Att: Director –Infrastructure Projects
Department of Planning and Environment
Application number –SSI 13_6136
Major Projects Assessment
GPO Box 39 Sydney NSW 2001.

Air quality and the southern interchange at Pennant Hills

This submission split into five parts in order to identify how the high air quality (2014) standard can be maintain/monitor/control within 2 KM surrounding resident area when the high concentrated pollutant emitted from both (35M height) ventilation outlets for NorthConnex tunnel operation in 2019:

Figure 1 Air Quality from RMS222_NorthConnex_Factsheet_DetailedAirQuality_Southern.pdf

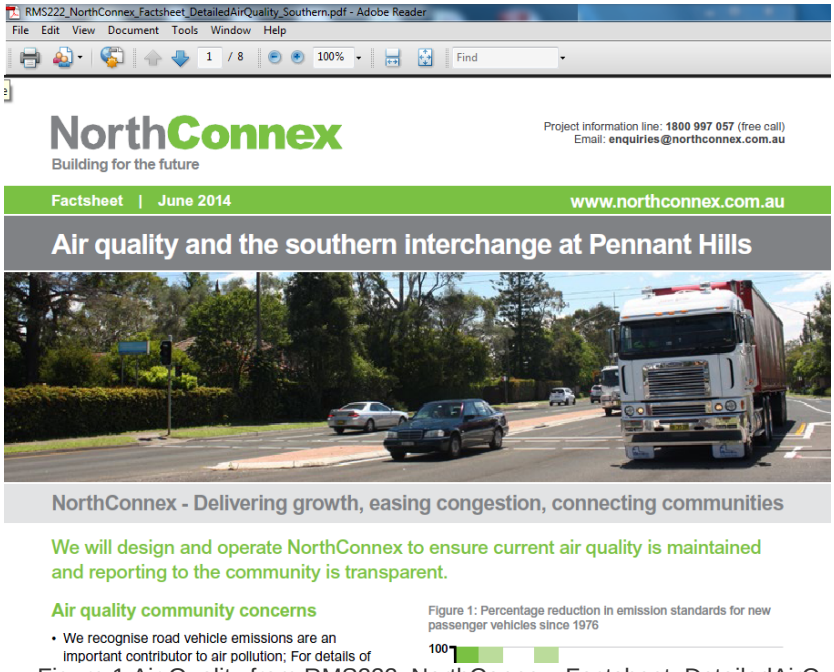
Figure 1 is the Fact sheet (June 2014) Air Quality proposed solution by NorthConnex for Southern Interchange. Dual (one upward and one downward/reversed) Air flow tunnels (9.2 KM) will be built from southern interchanges (144M Aust Height Datum) to northern interchange (180M Aus Height Datum). An estimated 4,000vehicles/hr will pass through the tunnel. High concentrated pollutant (bad air quality) generated by In-tunnel vehicles and will be drawn away by moving traffic and then extraction through a (30~35) M height ventilation outlet at both entries. Filtration technology (M5 East Tunnel filtration plant) will NOT be used.

B3. Without the NorthConnex project, the total amount of pollutant is evenly distributed along the pennant hill road, the good AQ maintains. With NorthConnex project, the total amount of tunnel pollutant is centralise and released at two spot of ventilation outlets. As such, the overall AQ is not improved. It just collecting (Pennant Hills road path) bad AQ to be released at two spot of ventilation outlets and make worst (Bad AQ) within 2KM surrounding resident area from two ventilation outlets.

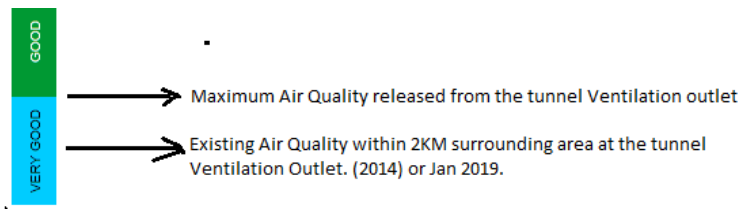
C4. Within the very good (blue colour) Air Quality indication, the requirement to set up the limit of pollutant concentration released from the tunnel ventilation outlets are:
